October 11, 2022

**Re: Lawrence Farmland, LLC
Preliminary and Final Major Subdivision
Block 147, Lots 42.06, 42.07, 42.08, 42.12, 42.13, 42.16
Exmoor Drive and Sutton Place
Planning Board
H2M Project No.: MENT2205**

Block 142, Lot 8 on Township of Mendham Tax Map

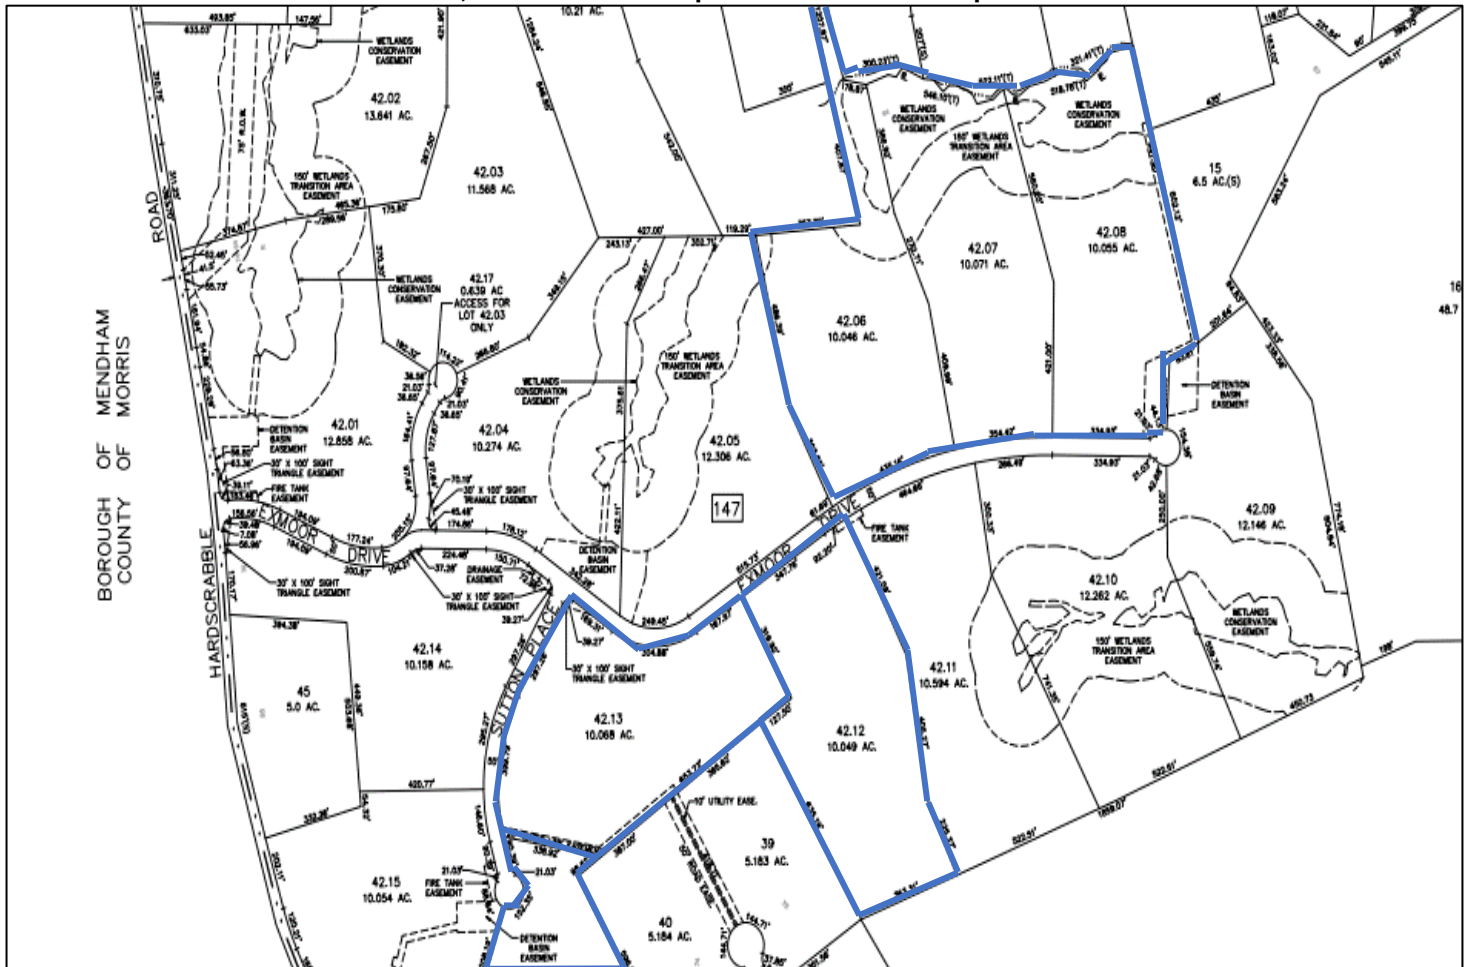
The applicant is submitting an application for a major subdivision to permit six (6) existing lots to be subdivided into nine (9) lots at its property located on Exmoor Drive and Sutton Place designated as Block 147, Lots 42.06, 42.07, 42.08, 42.12, 42.13, and 42.16 on the Tax Map of the Township of Mendham, New Jersey. The property is located in the Township’s R-5 Zoning District. Each of the proposed lots resulting from the proposed subdivision exceed the minimum lot size of five (5) acres with an average lot size of 6.71 acres per lot. The proposed lots within the subdivision conform to the bulk requirements of the R-5 Zoning District as shown in the **Bulk Standards** table. There are minimal proposed infrastructure improvements proposed as the roads with accompanying drainage systems to the newly proposed lots (Exmoor Drive and Sutton Place) are already constructed.
